Final Draft Report
Expedited System Impact Assessment
Hydro One Networks Inc.

**115 kV Switch on Tap L7S to St. Mary's Cement CTS
CAA ID # 2008-EX381**

Fig. 1 - Single Line Diagram

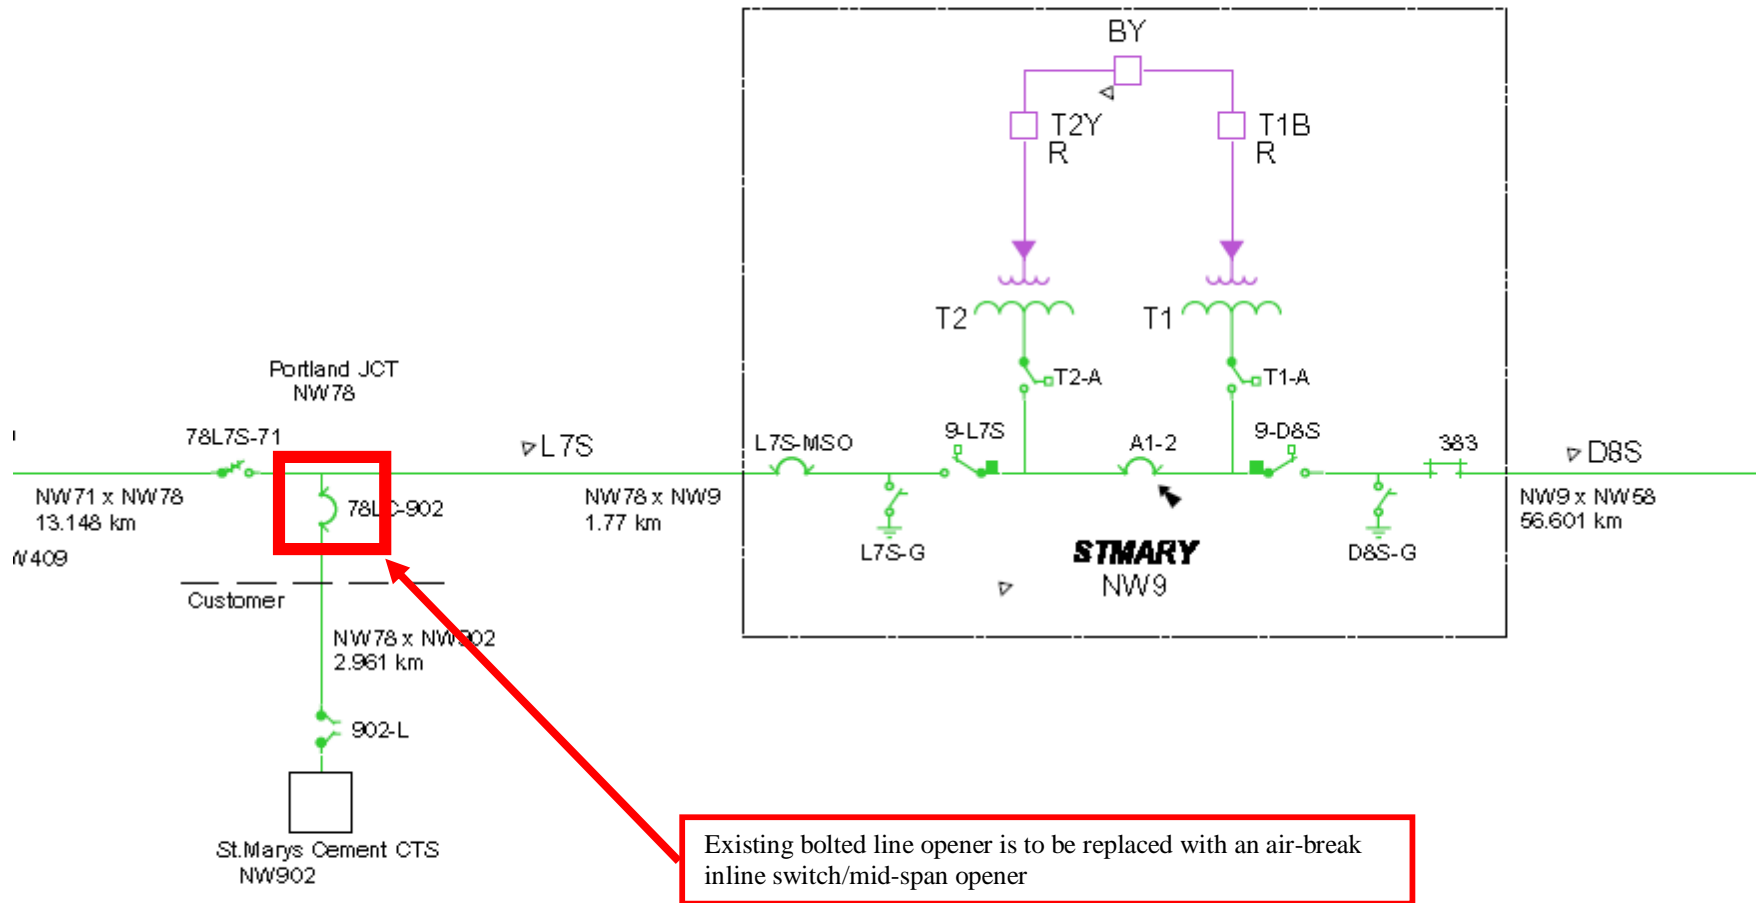
The bolted line opener at L7S Tap to St. Mary's Cement CTS is to be replaced with an air-break inline switch or mid-span opener by December 1, 2010. The existing configuration is shown in Figure 1.

The Transmission System Code (TSC) indicates that the transmission system has to be designed to sustain short circuit currents of 50 kA for the 115 kV system. This means that equipment designed to interrupt current must be able to handle short circuit currents up to 50 kA. Based on a numeric evaluation alone, the new circuit switcher does not meet this TSC requirement.

However, it should be noted that the new switch will not be used to interrupt system faults and will only be used to isolate the load when necessary. In this way, the switch need only be rated for the maximum amount of short circuit current that would be expected at St. Mary's Cement CTS. Based on Hydro One studies, system fault levels at that location do not exceed 2.5 kA.

Hydro One must ensure that the short circuit current seen by the new switch does not exceed its short time rating. If any future system enhancements in the area result in short circuit levels higher than the capability of the new switch, Hydro One is required to replace the new equipment with higher rated equipment at their expense.

The short time rating of the new circuit switcher is adequate for the expected fault levels at that location as confirmed by Hydro One. Should future system changes result in fault currents greater than 2.5 kA, Hydro One will be required to change the circuit switcher at their expense.
